PCN DETAILS

Note: While responding, please retain "PCN Notification : PCN Notification: 515187 " in the e-mail Subject line for faster response.

After Picture

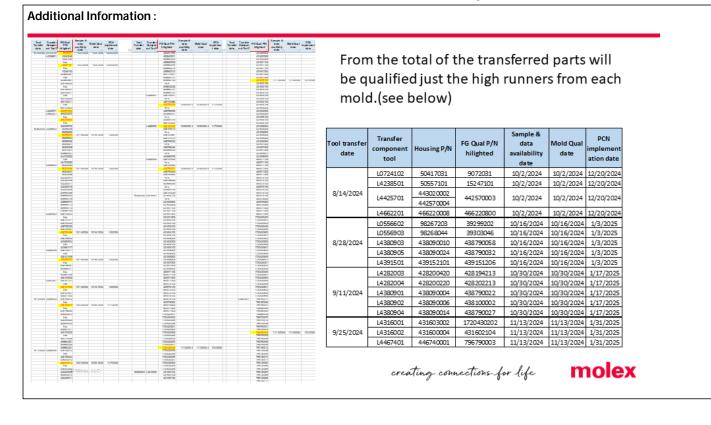
- We are shortening the component supply chain to maintain and improve delivery performance. Shipments of component injection molds will start in August 2024 and conclude in September 2024.
 - · Only production molds are being transferred.
 - No resin supplier changes are being made. Resin will continue to be sourced from the same supplier and manufacturing location
- Product Impact None, no change to form, fit or function
- Molex part numbers impacted see attached list
- Qualification Reports and samples for <u>finished goods</u> (FGs) available upon request
 - To streamline the qualification and customer approval process, a qualification FG with the greatest customer impact has been identified and highlighted in the following chart
 - · Samples and qualification reports these FGs will be available per schedule provided
